Environmental Minor Project Refinement Form

Project Name: West of Devers Upgrade Project Request Prepared By: Sylvia Granados

Date Approval Required: January 4, 2021 Variance Request No.: 43

FIGURE 1
Page 8 of 9

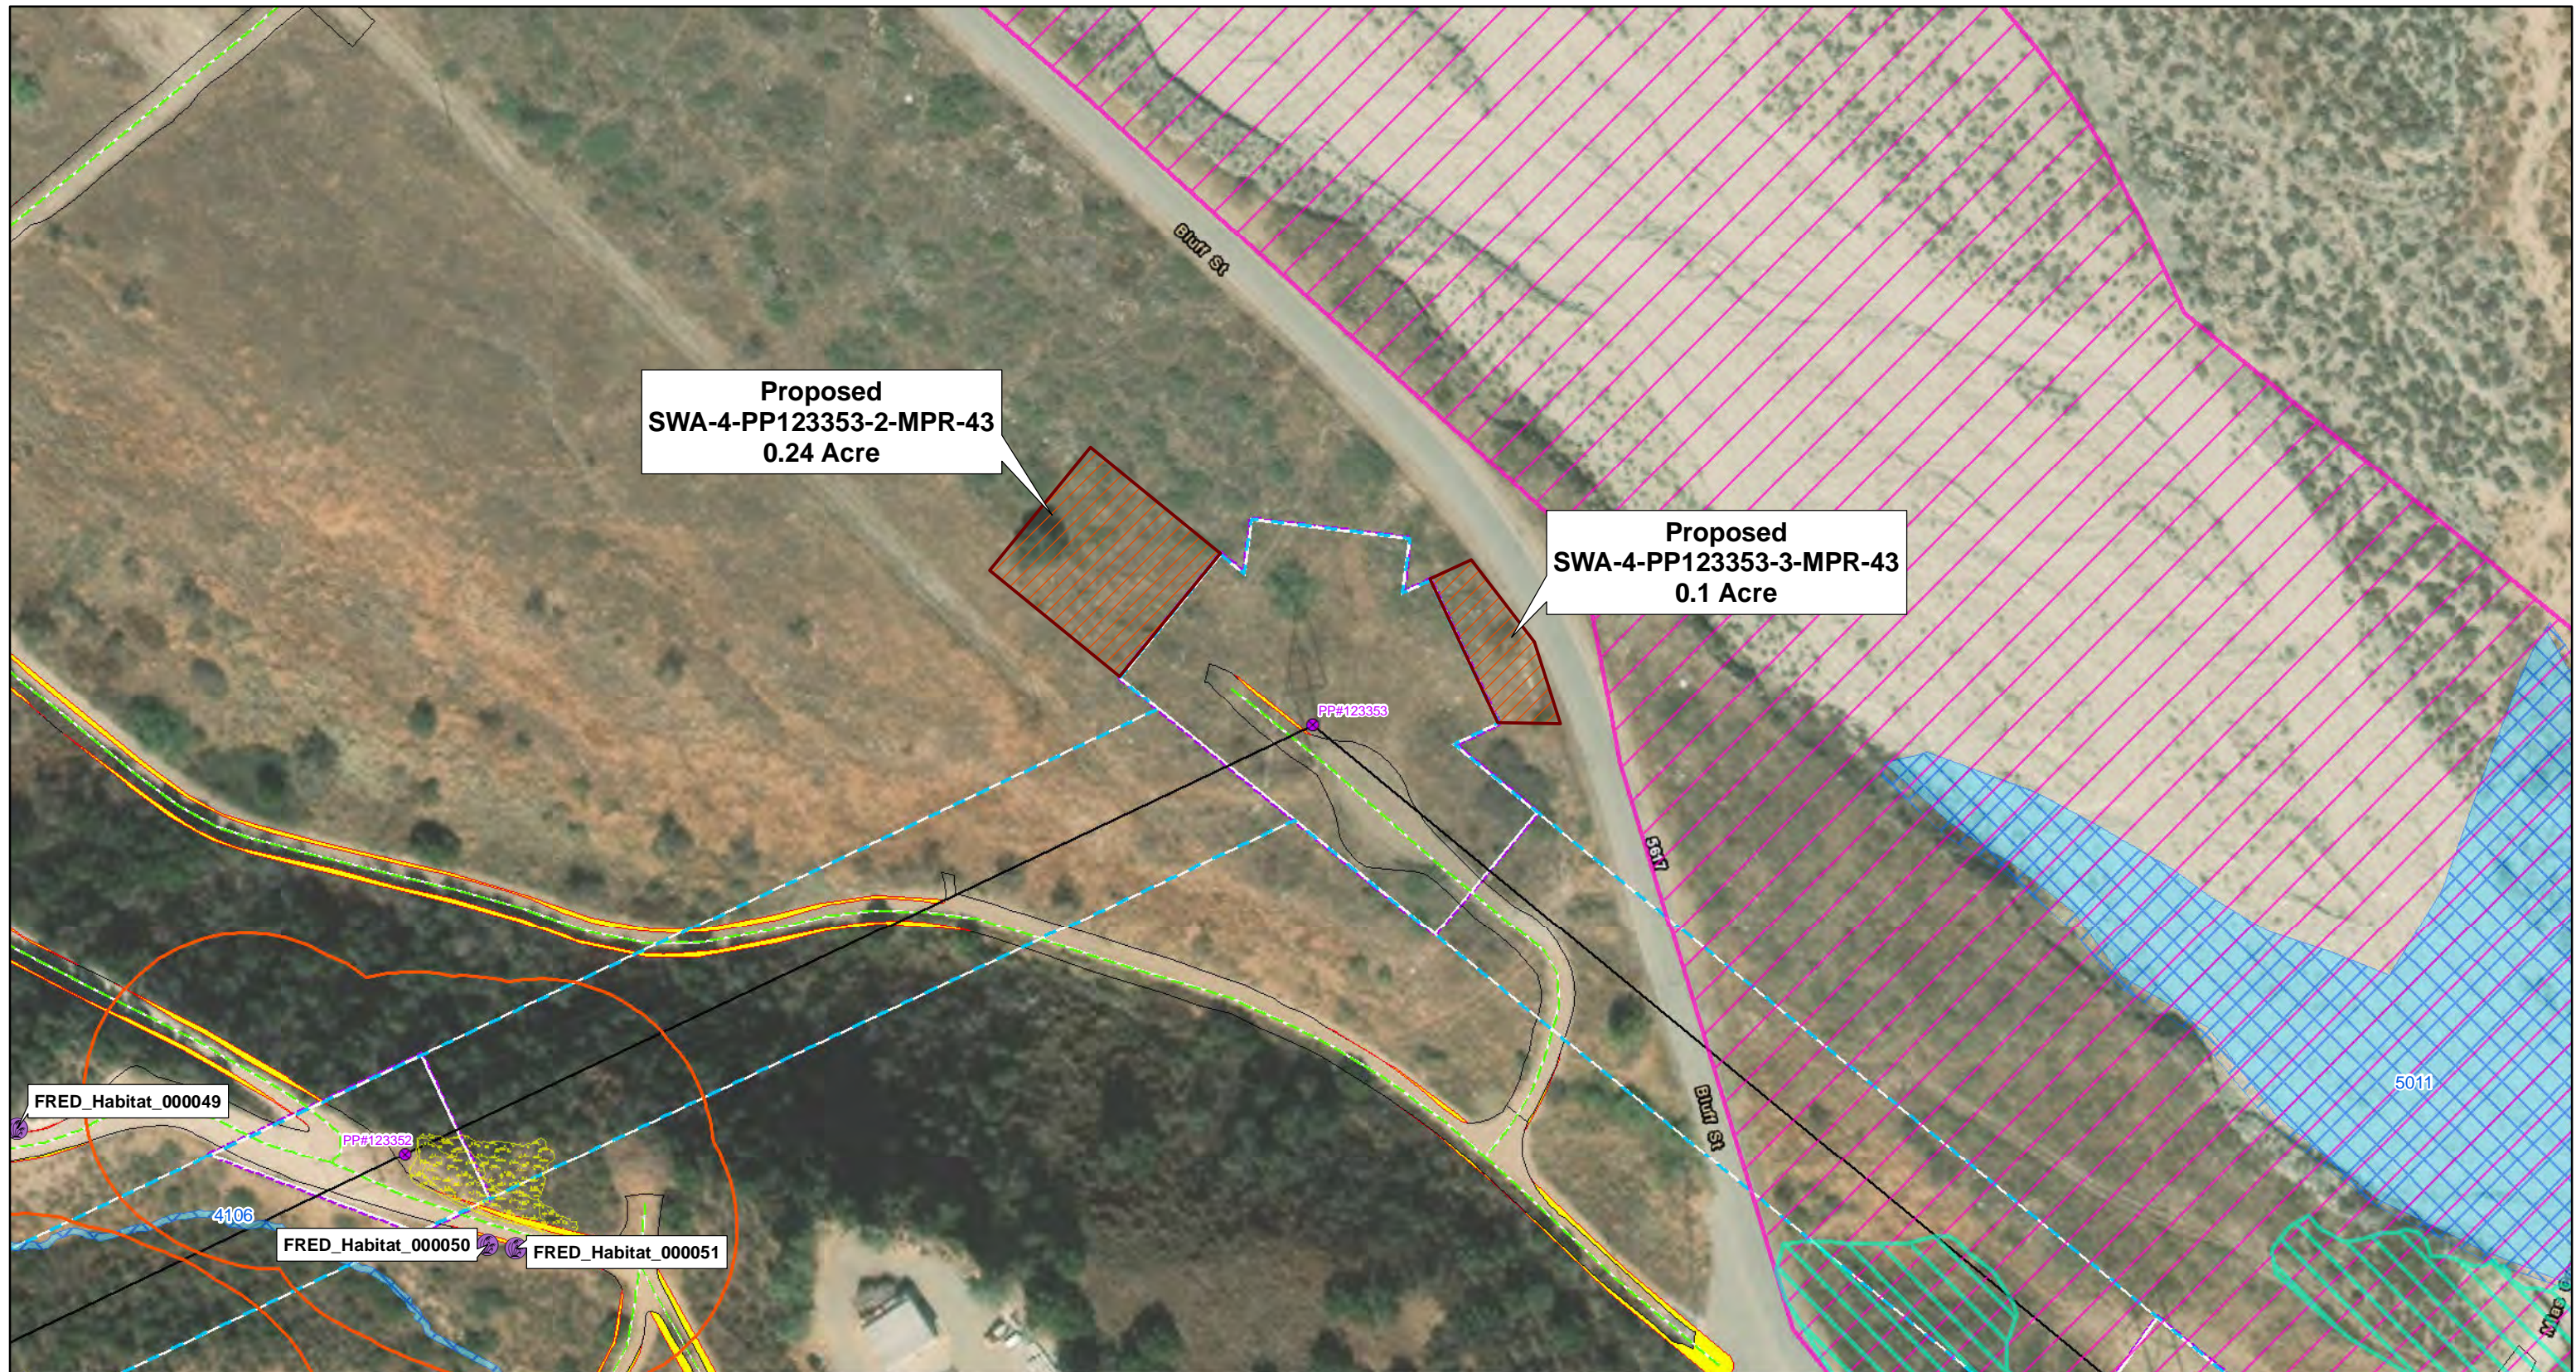
A new temporary 0.24 acre work area adjacent to the northwest side of Supersite PP123353 is required to safely stage material and equipment during wire wreck-out activities associated with PP#123353.

A new temporary 0.1 acre work area adjacent to the east side of Supersite PP123353 is required to safely stage material and equipment during wire wreck-out activities associated with PP#123353. Both temporary work areas are shown on Figure 1, Page 9.

The new temporary work areas will result in approximately 0.34 acres of temporarily impacted public property owned by the City of Banning and consisting of 0.237 acre of desert scrub, 0.082 acre of grassland/forbland, and 0.021 acre developed disturbed land.

FIGURE 1
Page 9 of 9

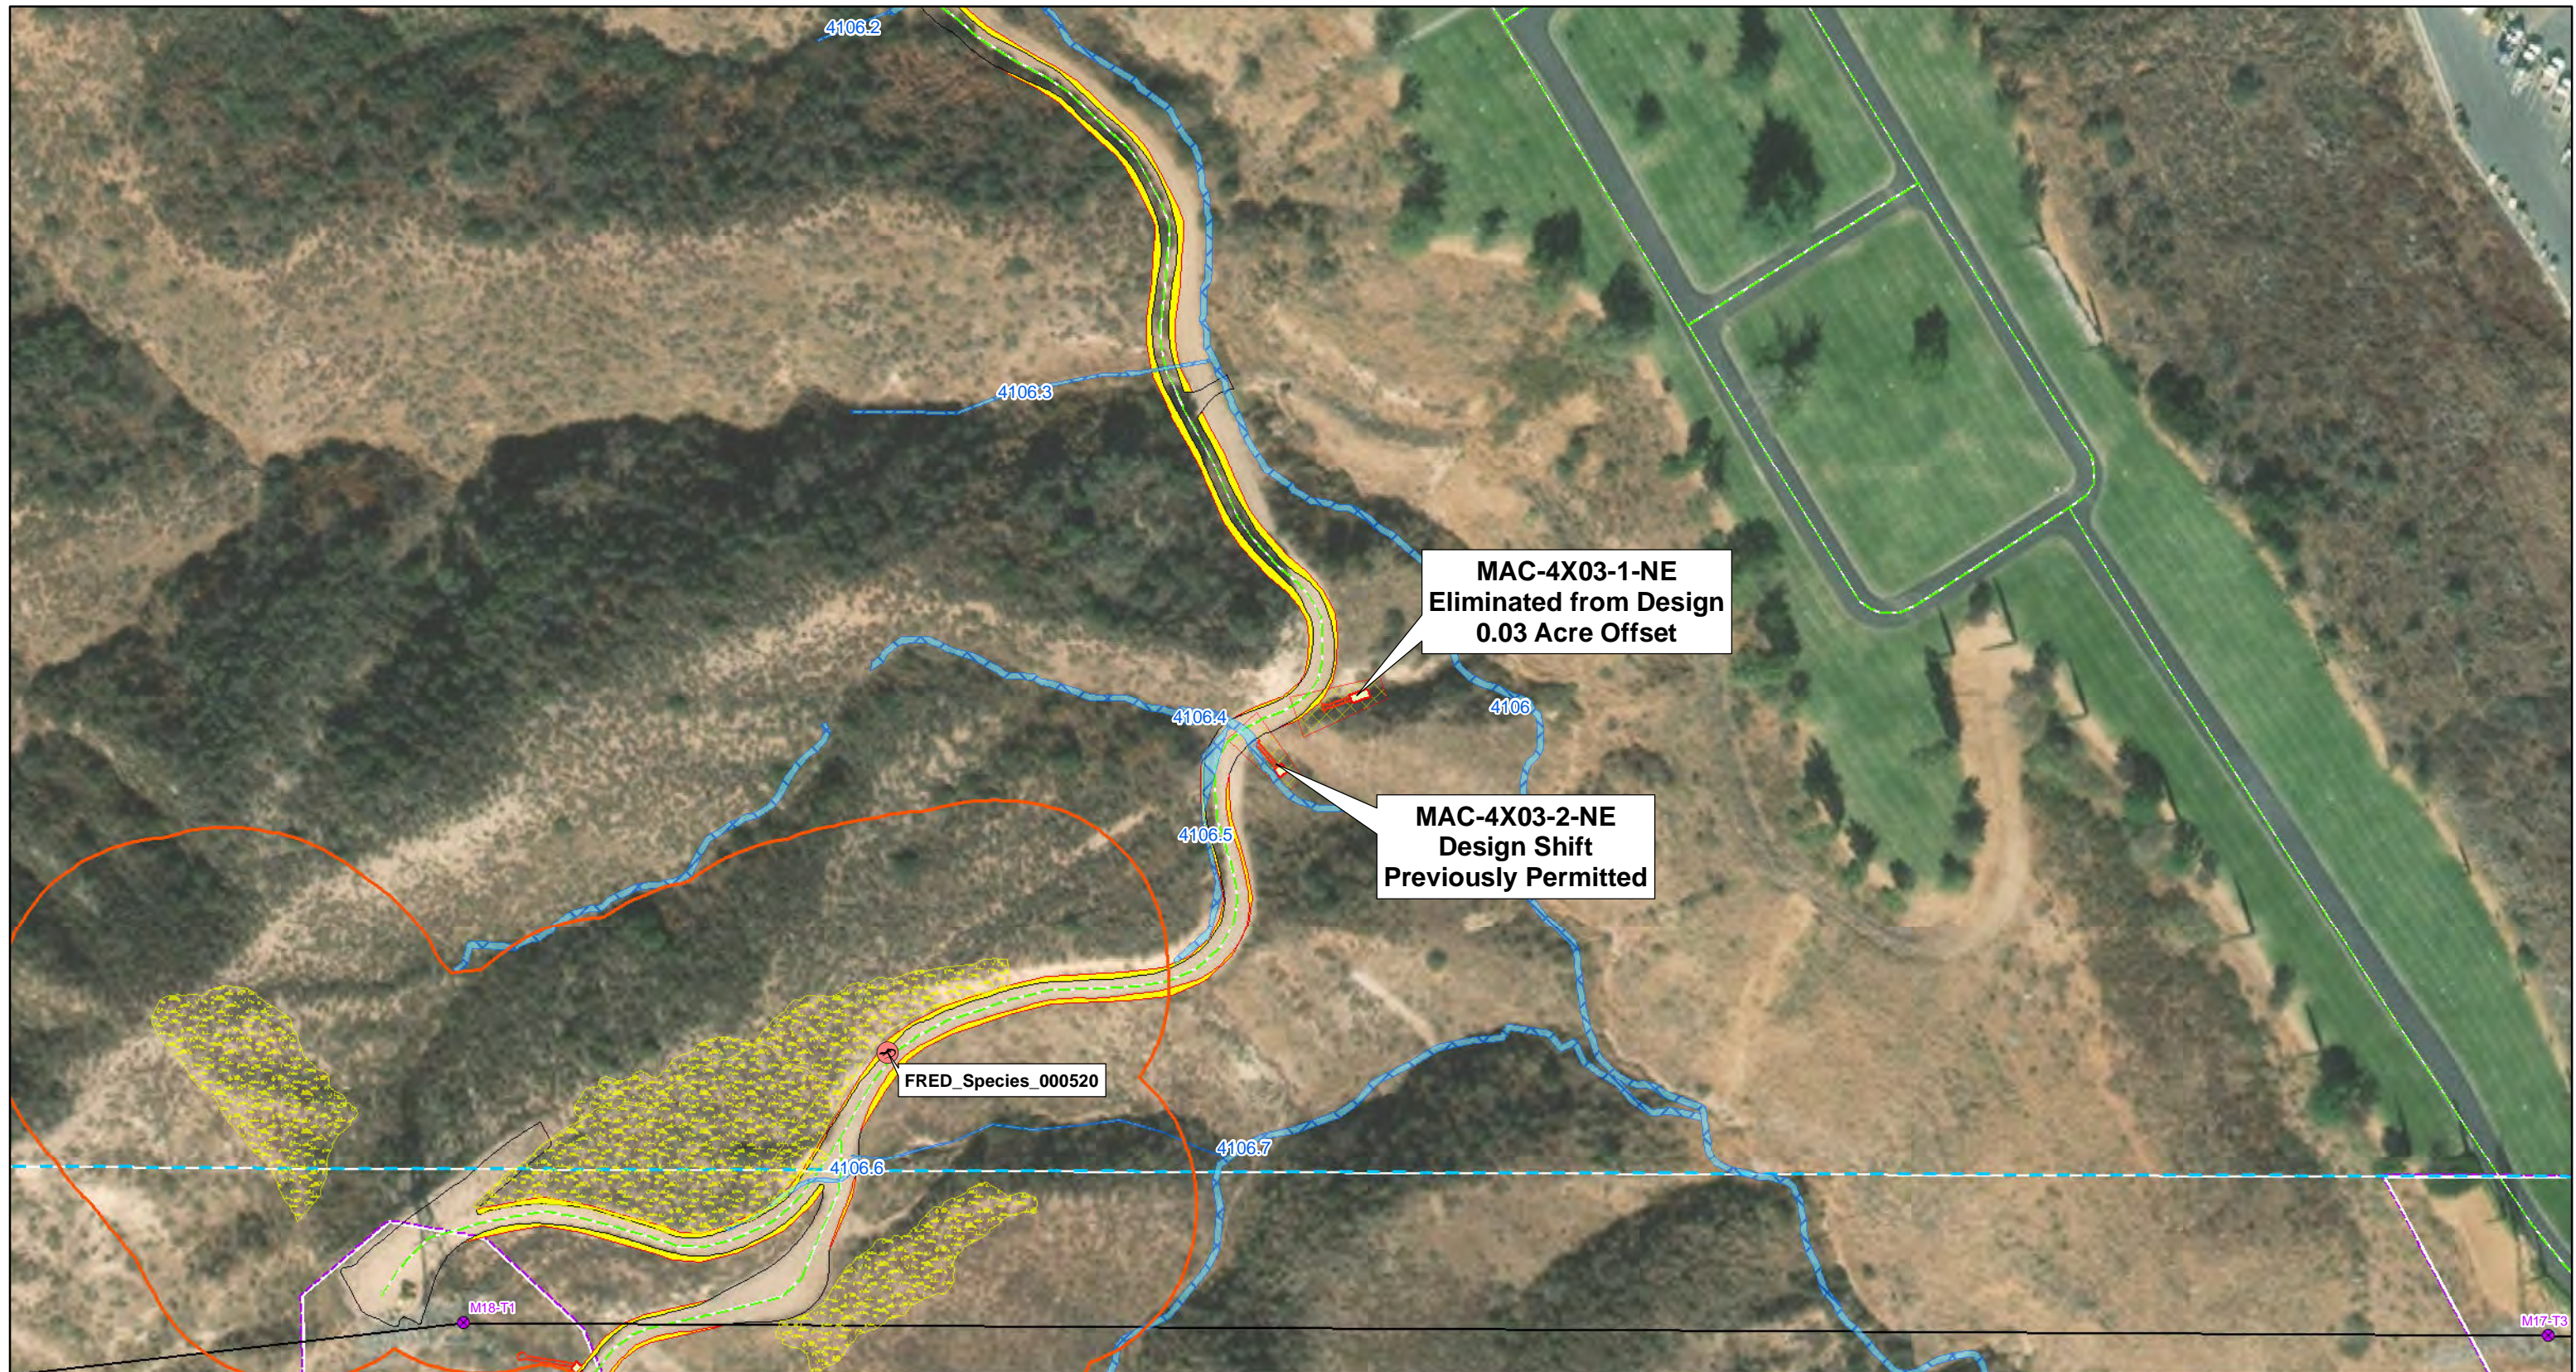
McCarthy drain MAC-4X03-1-NE has been eliminated from the final design. In addition, the design of MAC-4X03-2-NE (located approximately 660 feet northeast of 4N03) will be shifted approximately 2 feet northwest and tied into the existing roadside berm. The location of the design adjustments are shown in Figure 1, Page 9.

The elimination of MAC-4X03-1-NE and design shift for MAC-4X03-2-NE will result in a reduction of temporary impacts by approximately 0.03 acre and reduction of permanent impacts by approximately 0.003 acres. Impacts to jurisdictional
